February 13, 2023

**SAN CARLOS AIRPORT RUNWAY 12-30 & CONNECTOR TAXIWAY REHABILITATION
PROJECT**

**COUNTY PROJECT NO. ASL03
PROJECT FILE NO. E5077**

ADDENDUM NO. 1

CD101(REV 1)
SHEET 8 OF 53

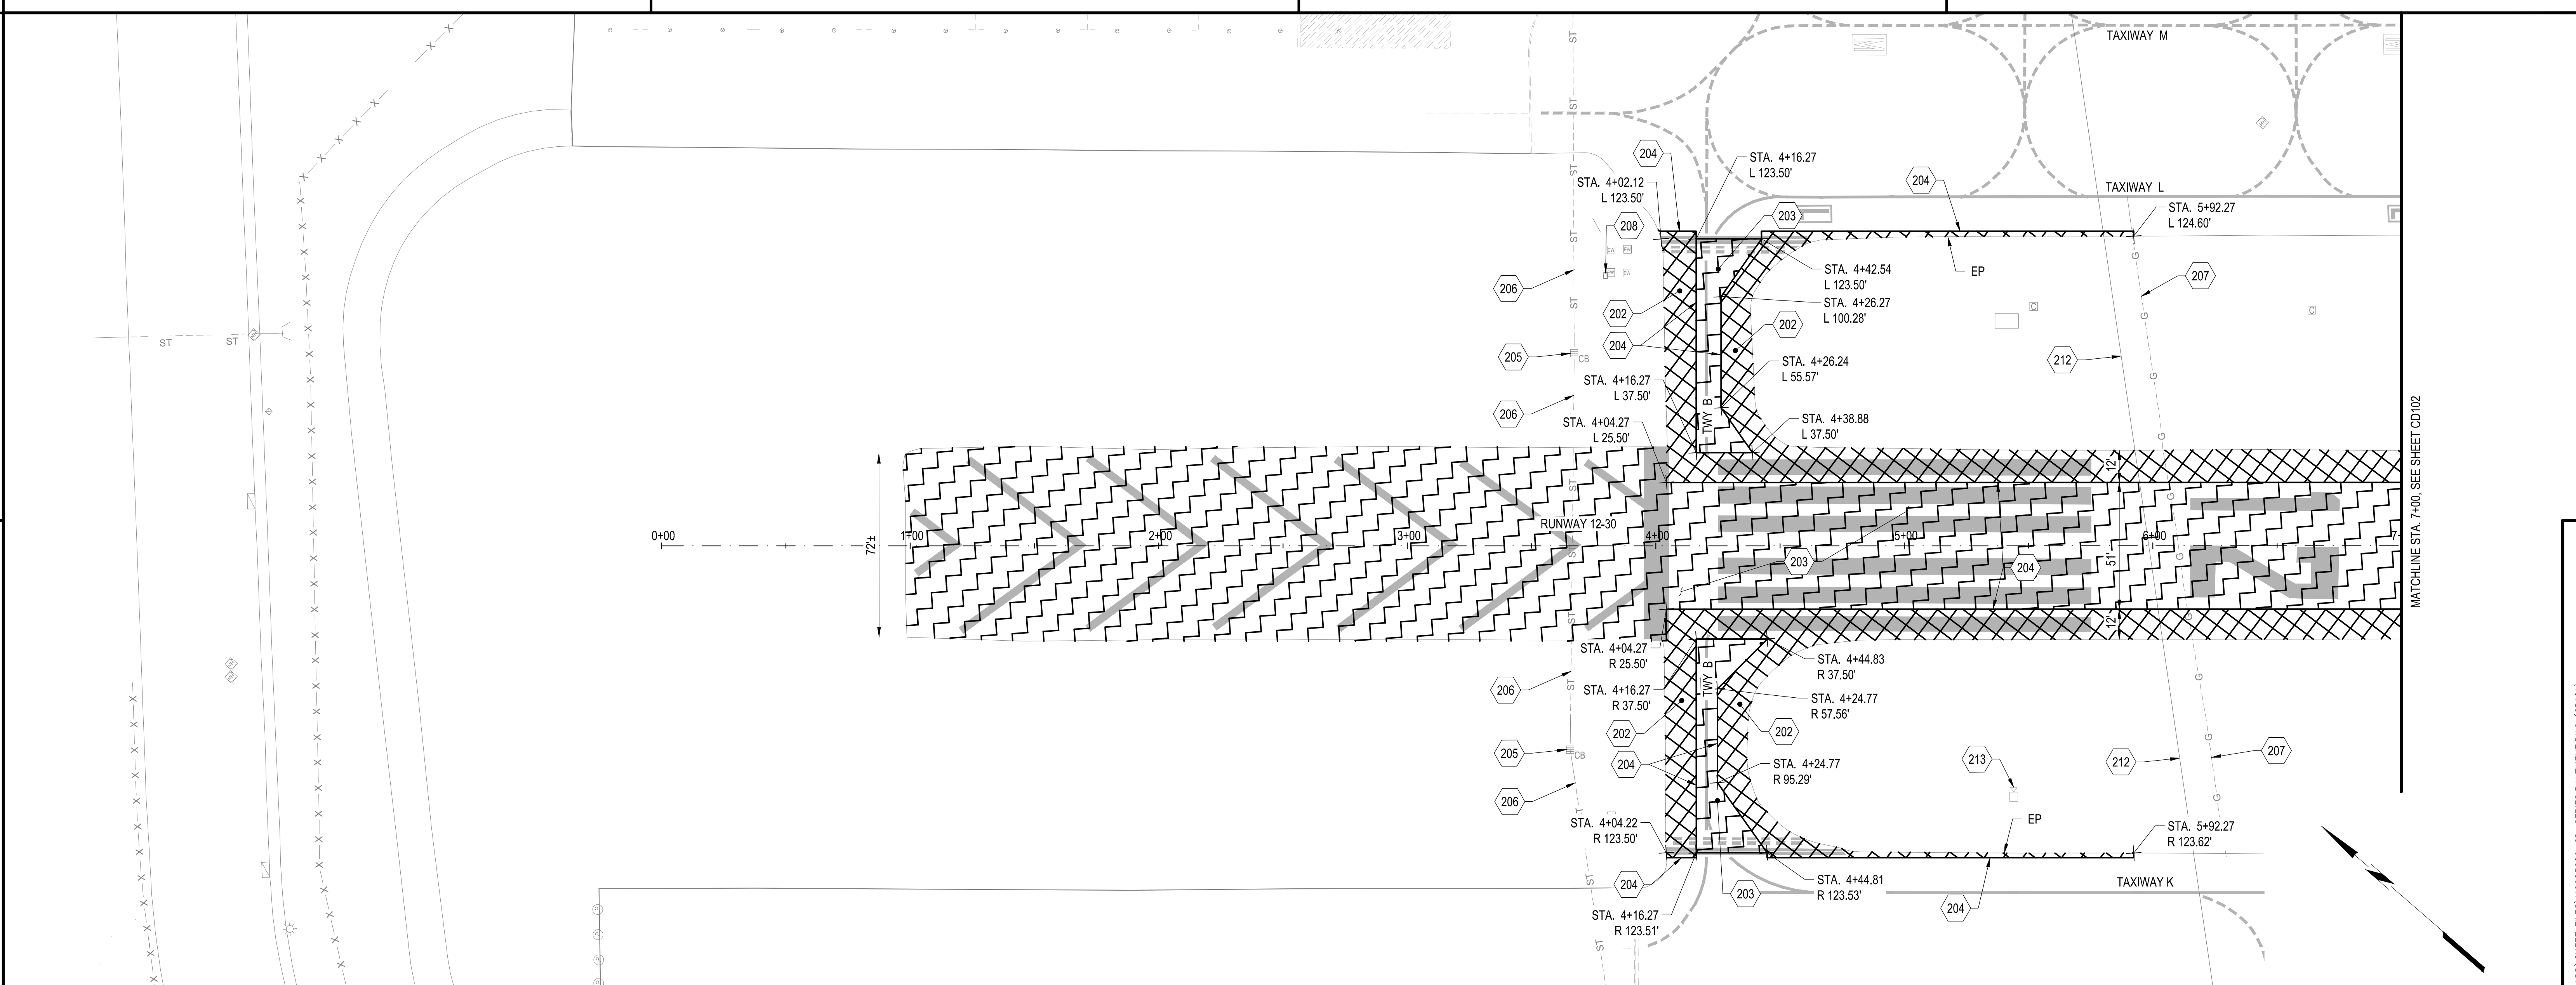
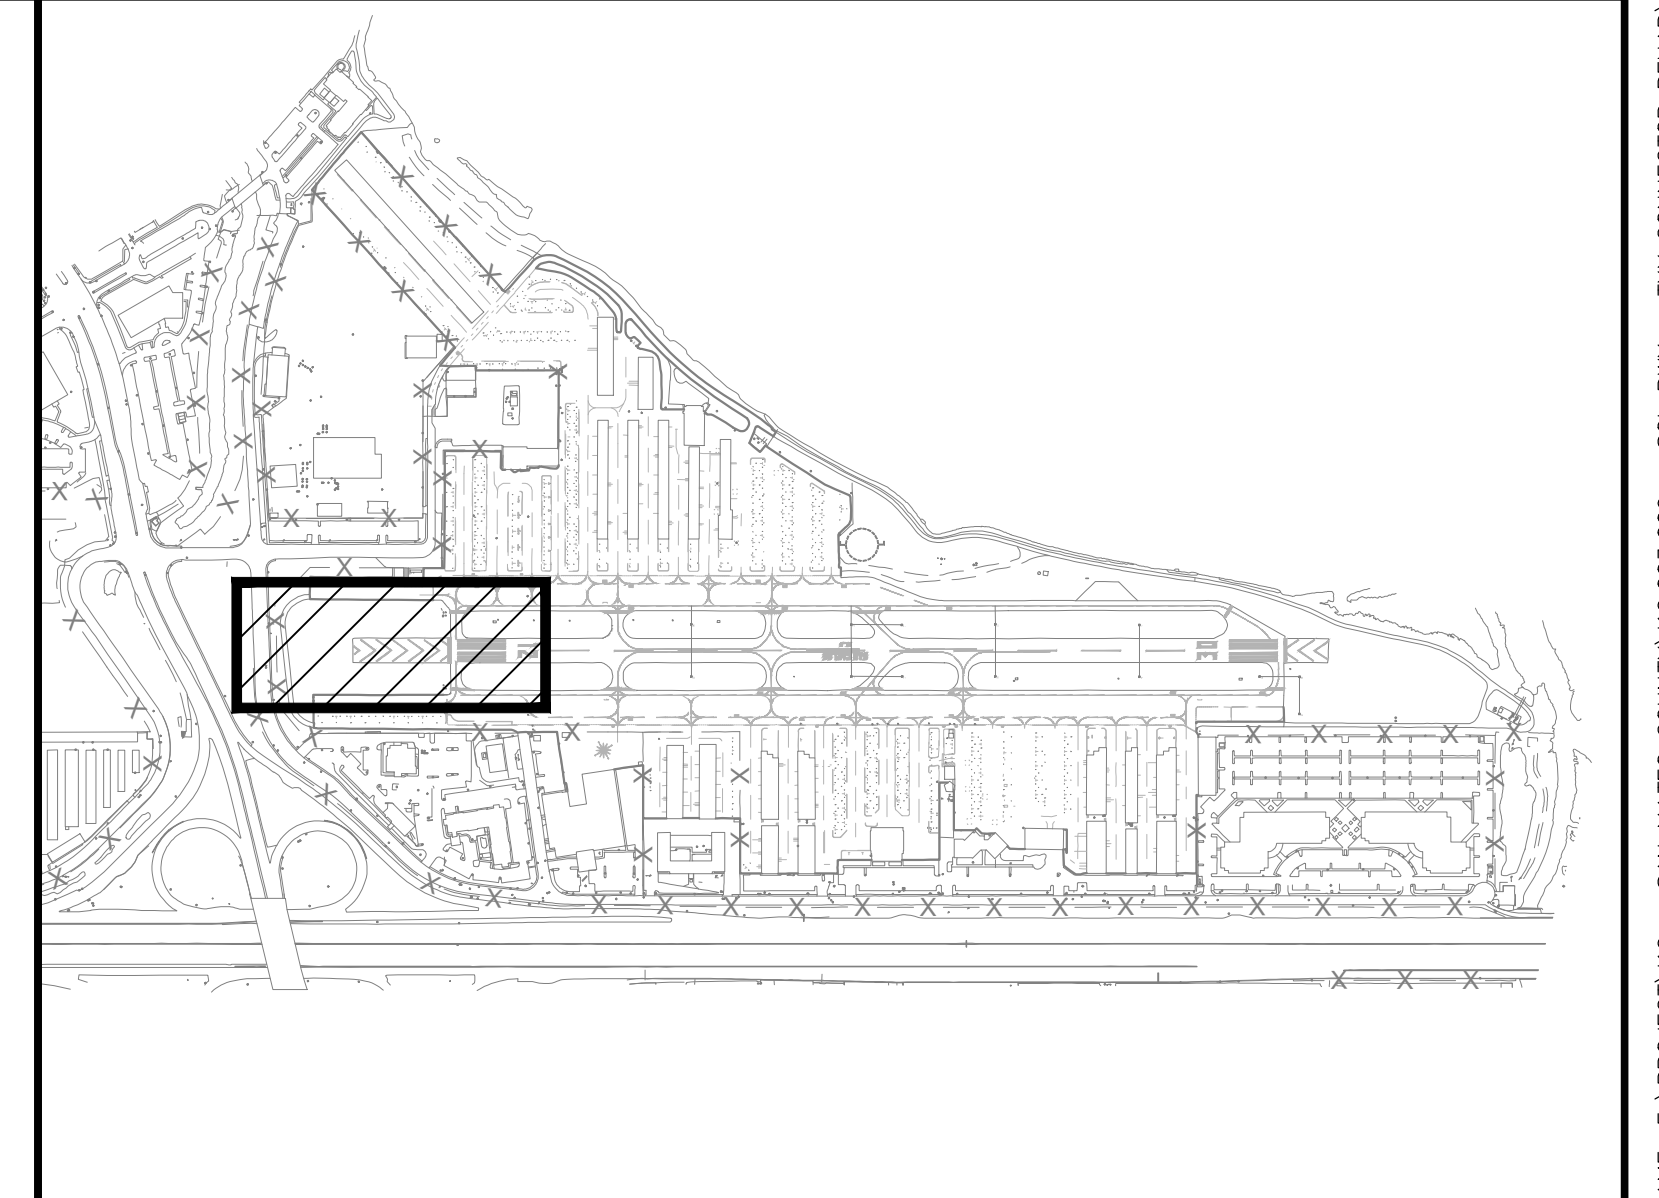
1. The approximate depth of the existing utility tunnel has been added on plan sheet CD101:

Replace plan sheet CD101 with plan sheet CD101 (rev1).

- 208. TELECOMMUNICATIONS STRUCTURE TO REMAIN, PROTECT IN PLACE.
 - 212. UTILITY TUNNEL TO REMAIN, PROTECT IN PLACE. TUNNEL ACCESS MANHOLE LOCATED WITHIN THE TRANSIENT PARKING APRON AREA AT APPROXIMATE STA. 5+47.24, L 351.67'. A DEPTH OF 28-INCHES WAS MEASURED FROM THE TOP OF THE TUNNELS INTERIOR WALL TO THE PAVEMENT SURFACE AT THE ACCESS MANHOLE.
